**NSW P&E Ref: 8_0167 Belle O'Connor St
08_0167 MOD2, Modification to Residential Subdivision - 08_0167 MOD 2**

RE: Section 75W Modification of Consent (MOD 2) –Lot 36 DP 1214499 Belle O'Connor Street, South West Rocks.

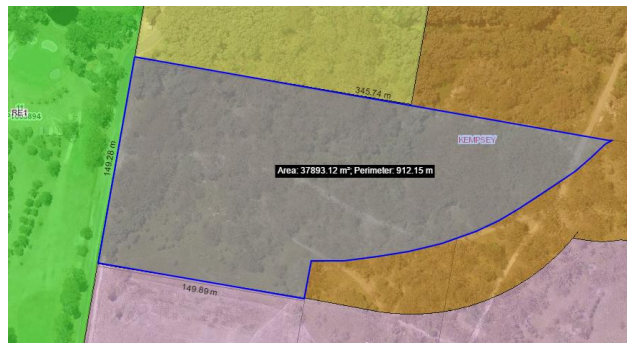
New intersection – An assessment of the traffic impacts associated with the new road connection to Burrawong Drive has not been provided nor is it consistent with the construction certificate plans for Stage 1A of the project that are currently being assessed by Council. For example, the location of the new road connection will impact upon (as depicted in the current plans for the Stage 1A construction certificate) utility services and the proposed culvert crossing the Burrawong Drive extension.

The new intersection will provide an alternative access to the approved subdivision in the location shown circled red below.

The modification is consistent with the arrangements shown in Figure 2 of the Traffic and Transport report prepared by Colston Budd Hunt & Kafes (April 2010). Specifically, the “indicative long term/future site access / design subject to Council specifications and subsequent approval.” Shown circled below.
